**SOUTH DAKOTA
WATER PERMIT NO. 8814-3**

**RECOMMENDATION OF CHIEF ENGINEER FOR WATER PERMIT
APPLICATION NO. 8814-3, Craig Arthur**

Report to the Chief Engineer
On Water Permit Application No. 8814-3

Craig Arthur

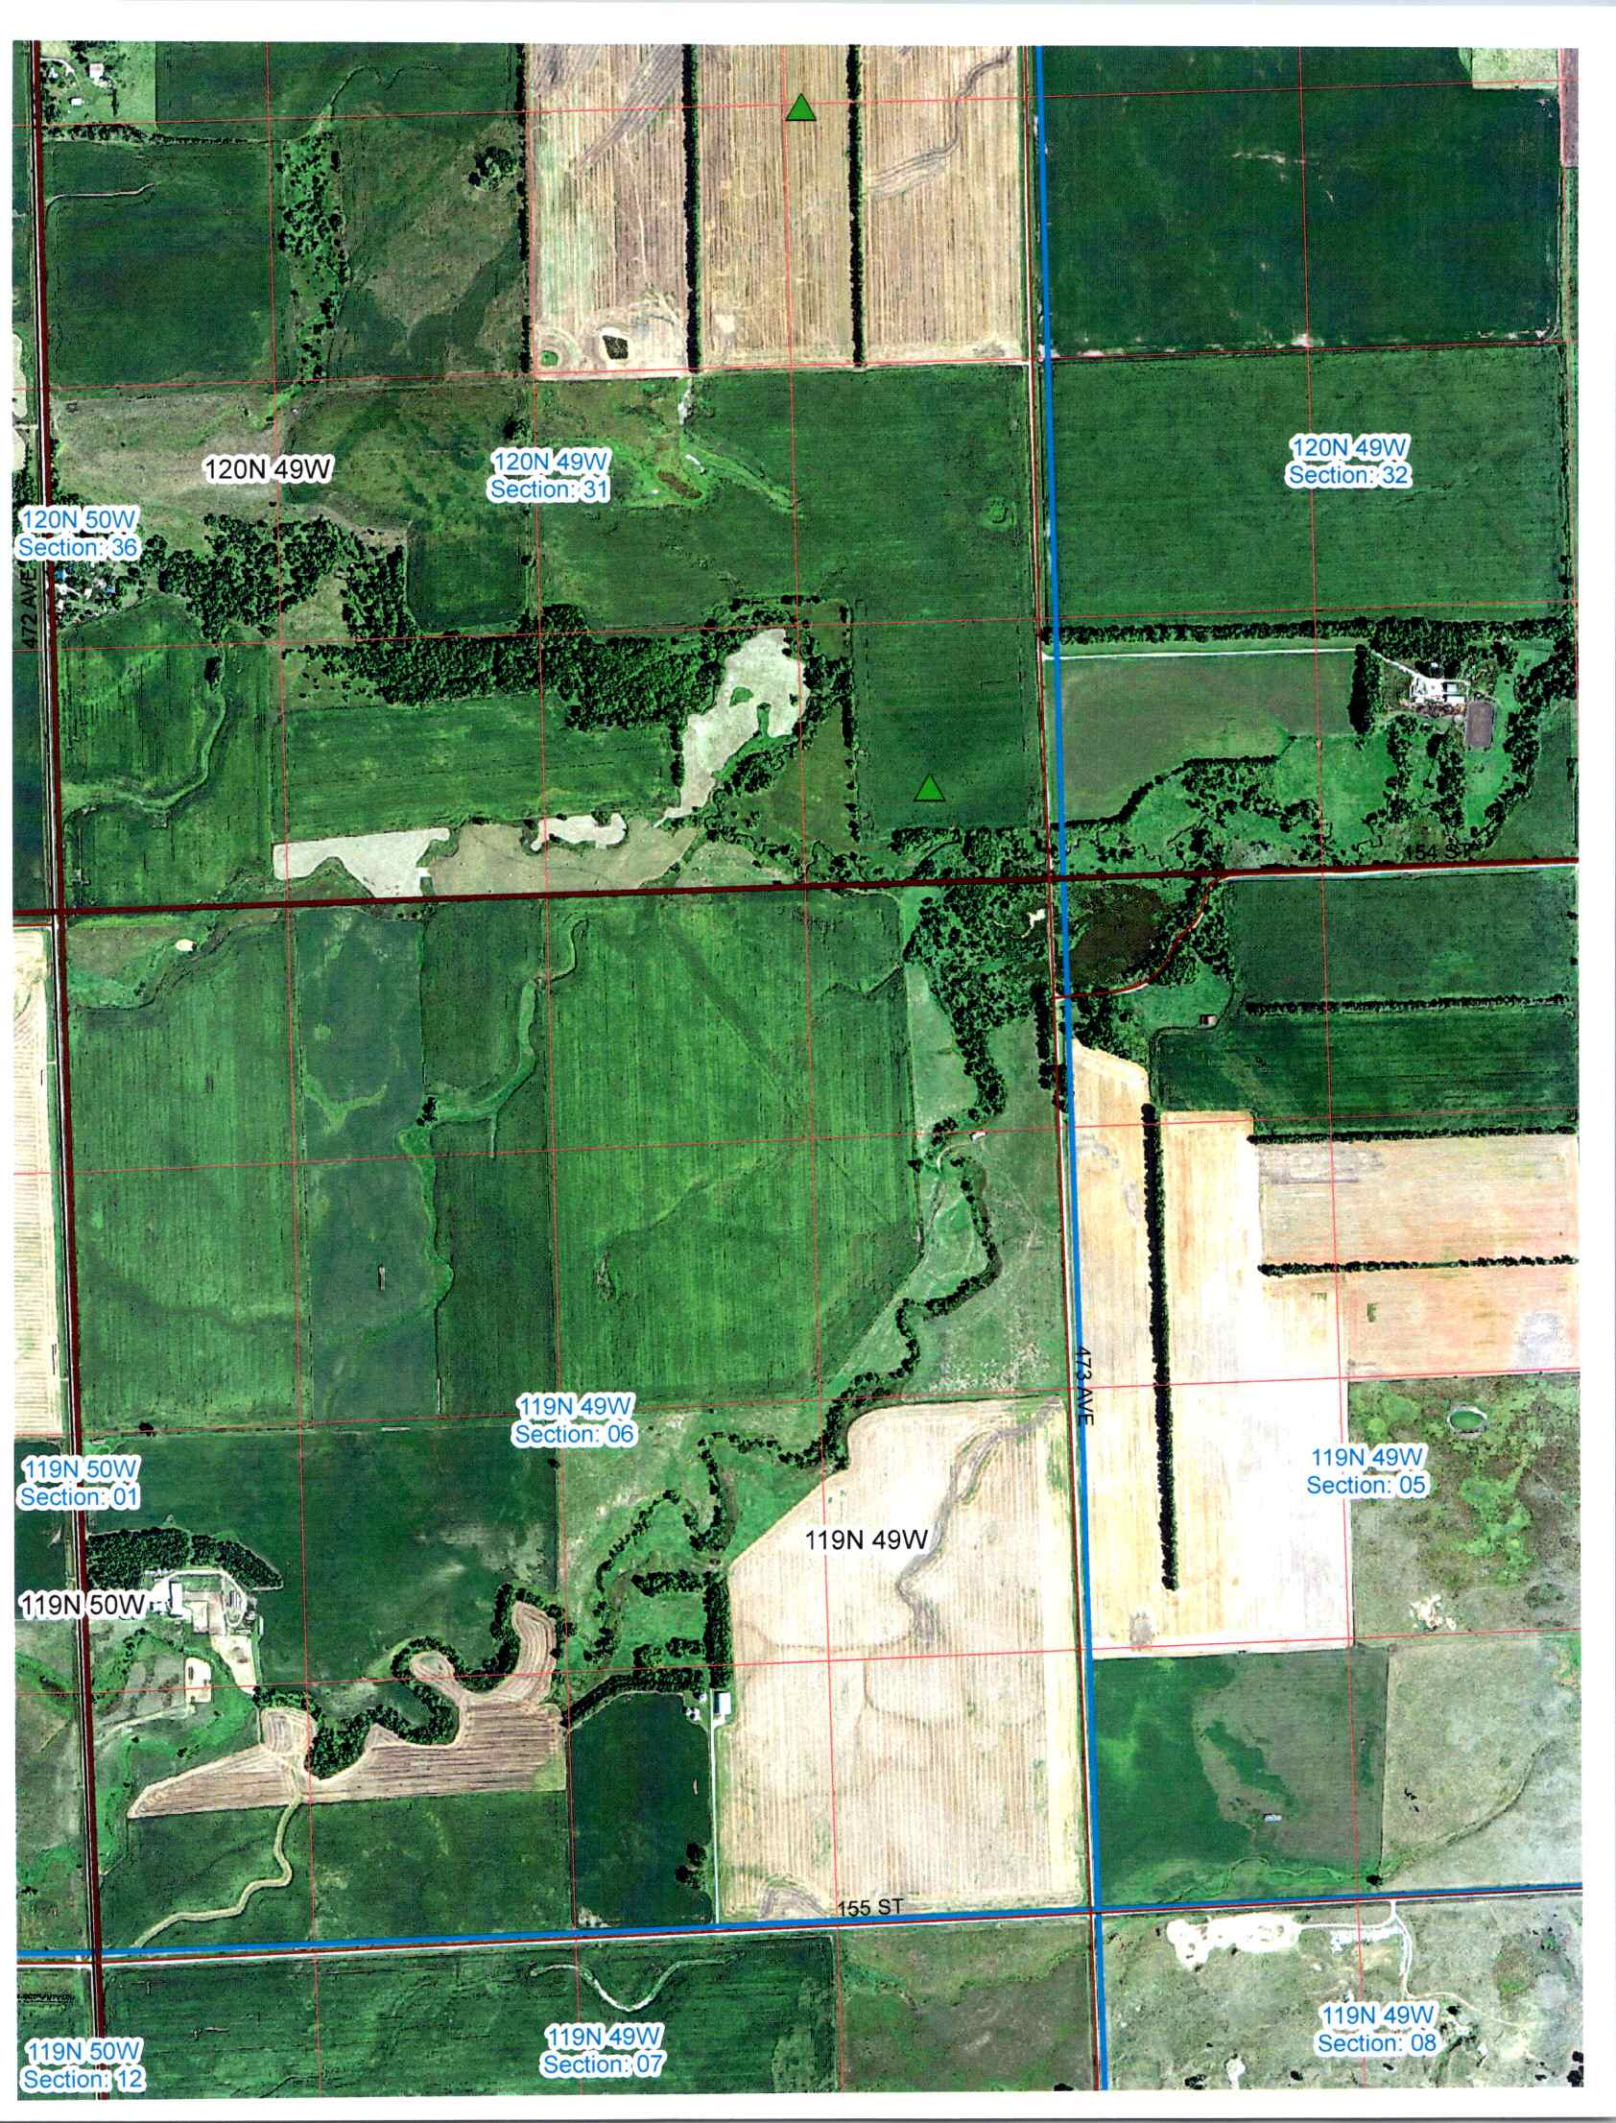
Here is an attached map from my irrigation salesman, it should have all the information you need. If this map isnt acceptable let me know, the existing well is marked on this map also by a white pin to the ne of the pivot. Whatever needs to be done to match this map is good with me. And yes adding existing well to page one is right there will not be a new well at this time as a long as the performance of the old one is acceptable. if you have any more questions let me know thanks.

- The land to be irrigated totals to 102 acres and you have total acreage of 101.74. Is it okay if I correct total acreage to match at 102? You will not owe any additional money.
- Attached is a map, please mark the location of the well and outline the acres to be irrigated, then return to me.
- You indicated an existing well on page 2, is it okay to add "existing" to page 1 where you have the location of the well. Or are you in fact, adding another well?

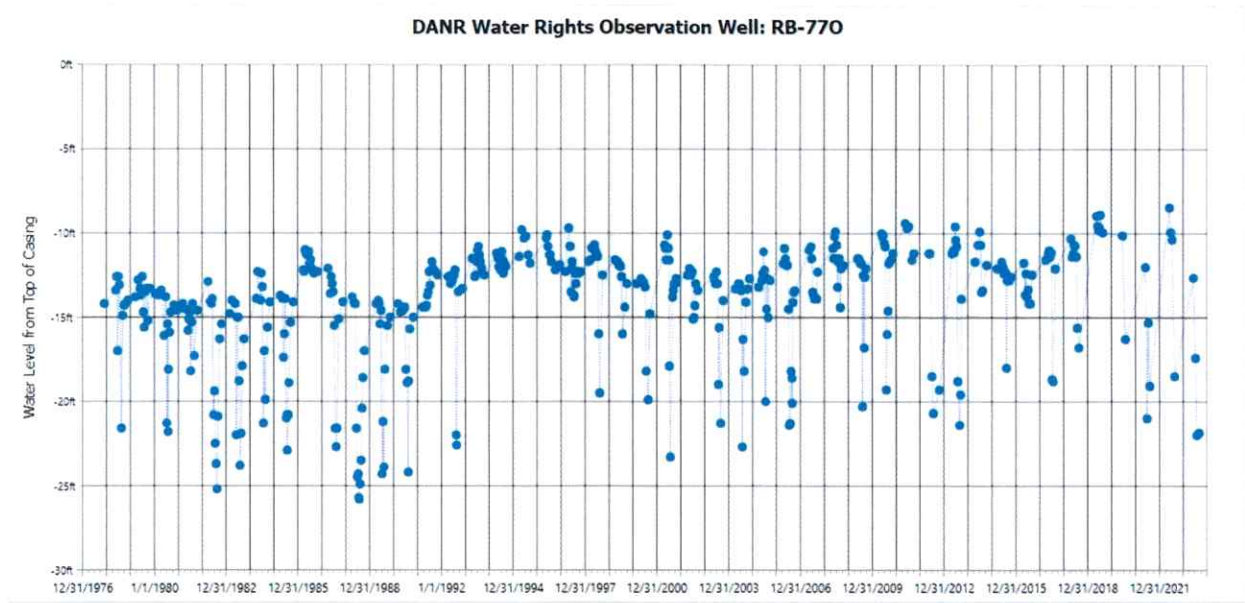
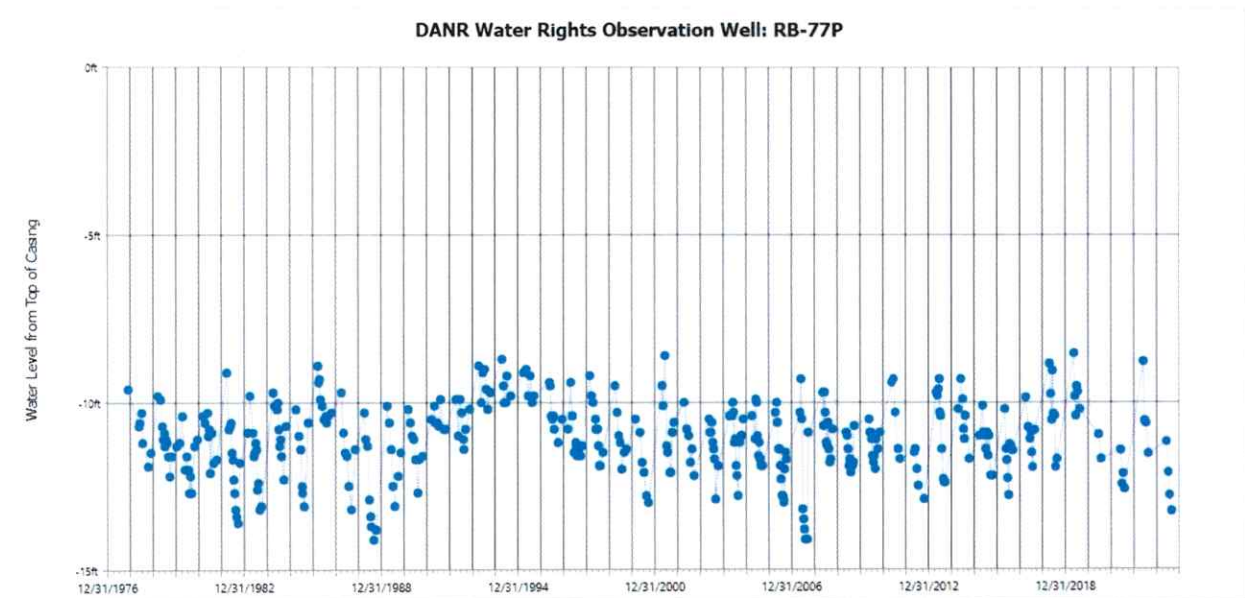
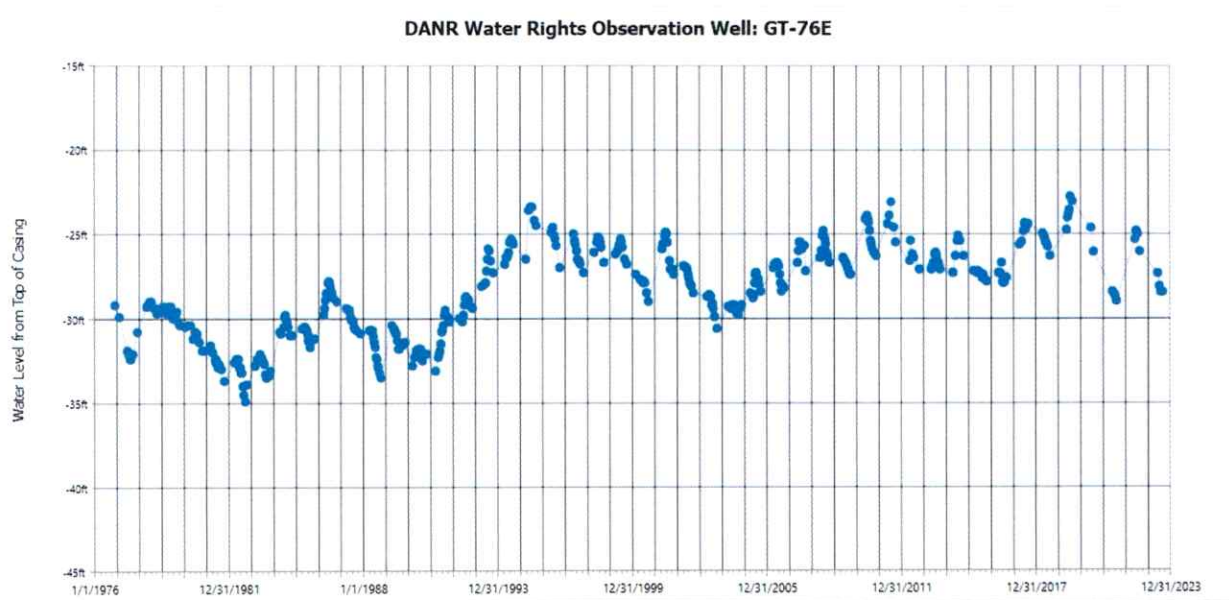
The hydrographs for the observation wells display stable to increasing water levels over their respective periods of record. The hydrographs for the Wilmot aquifer indicate that the aquifer responds well to climatic conditions because water levels are rising during wetter periods and declining to a stable water level during drier periods. Additionally, the water levels in the observation wells display that the amount of recharge to and natural discharge from the aquifer greatly exceeds pumping with the aquifer returning to pre-pumping conditions between irrigation seasons. Aquifer recovery indicates that climatic conditions and therefore, the effects of recharge to and natural discharges from the aquifer govern the long-term fluctuations of waters levels in

the aquifer rather than the impacts of pumping from the Wilmot aquifer. By recognizing that both recharge to and natural discharge from an aquifer can be captured for pumping, the observation well hydrographs demonstrate unappropriated water is available for the proposed appropriation.

Figure 3. Hydrograph for observation well RB-77Q (Water Rights, 2024b)

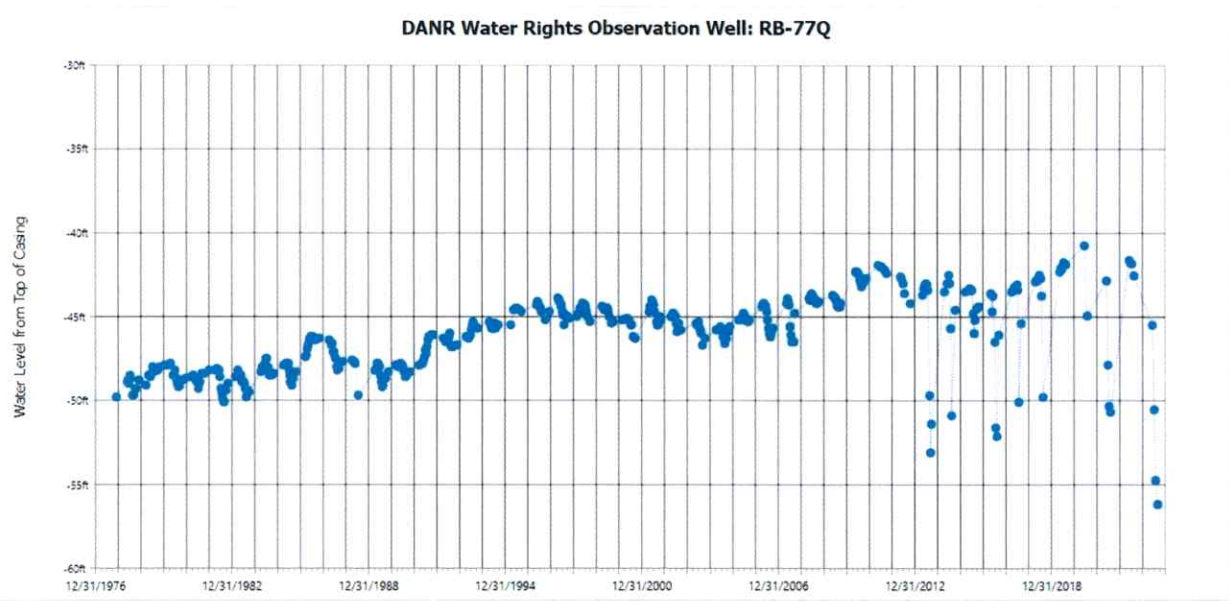
Observation well RB-77Q (approximately fifteen miles northwest of the existing well site) has four high-yield (assumed to be a well with an authorized diversion rate greater than 0.2 cfs) irrigation wells within approximately six miles of it (Water Rights, 2024b and 2024c). The drawdown from pumping can be seen on the hydrograph for RB-77Q, along with the aquifer returning to pre-pumping conditions between irrigation seasons (Figure 3) (Water Rights, 2024b). The lithologic log on file for RB-77Q noted the well was drilled 165 feet deep below the ground surface, had a casing stick up height of approximately 1.5 feet, and the top of aquifer materials approximately 131 feet below the ground surface (SDGS, 2024). The lowest recorded

static water level on the hydrograph (displayed in Figure 3) is approximately 56 feet below the top of the well casing, which indicates there was still approximately 75 feet of artesian head pressure in RB-77Q even during drier periods when high-yield wells are expected to be pumping more water and when water levels are generally naturally lower in response to drier conditions (SDGS, 2024; Water Rights, 2024b).

Figure 5. Location of the existing well proposed to be used by Water Permit Application No. 8814-3, with the Wilmot aquifer water rights/permits and observation wells (Water Rights, 2024b and 2024c)

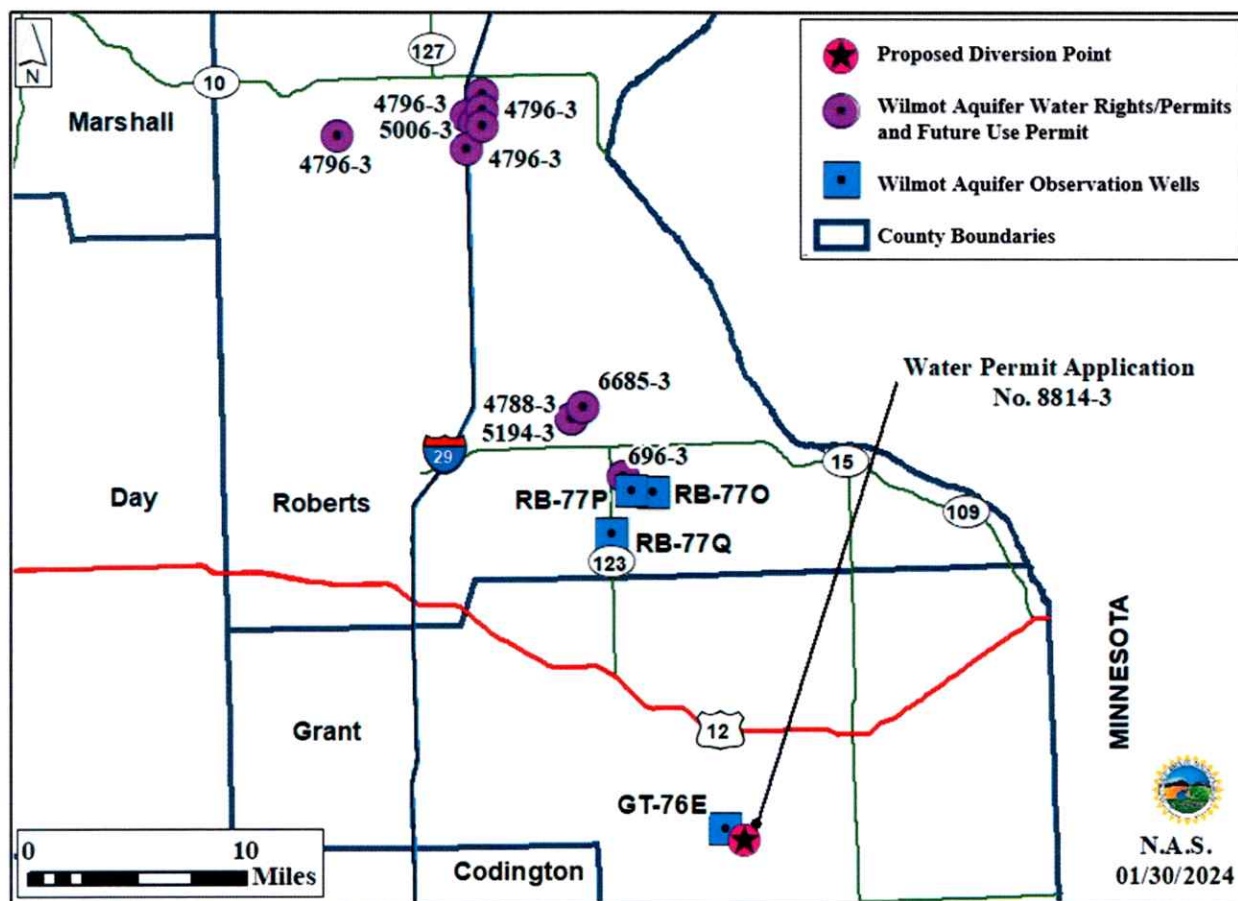
Currently, there are five water rights/permits authorized to appropriate water from the Wilmot aquifer, and one future use permit reserving water (Water Rights, 2024c). The closest water right/permit to the existing well site is Water Right No. 696-3, which is held by Brian Renelt. The diversion point for Water Right No. 696-3 is located approximately 17.5 miles northwest of the existing well site for this application (Table 3) (Figure 5) (Water Rights, 2024c).

There are domestic wells on file with the DANR-Water Rights Program that are completed into the Wilmot aquifer, with the closest domestic well on file (not held by the applicant) located approximately 0.8 miles northwest of the existing well site (Water Rights, 2024d). There could potentially be other domestic wells completed into the Wilmot aquifer near the well the applicant proposes to use that are not on file with the DANR-Water Rights Program. The location of the domestic wells in the well completion report database maintained by the Water Rights Program is based on the location listed by the driller on the well completion report.
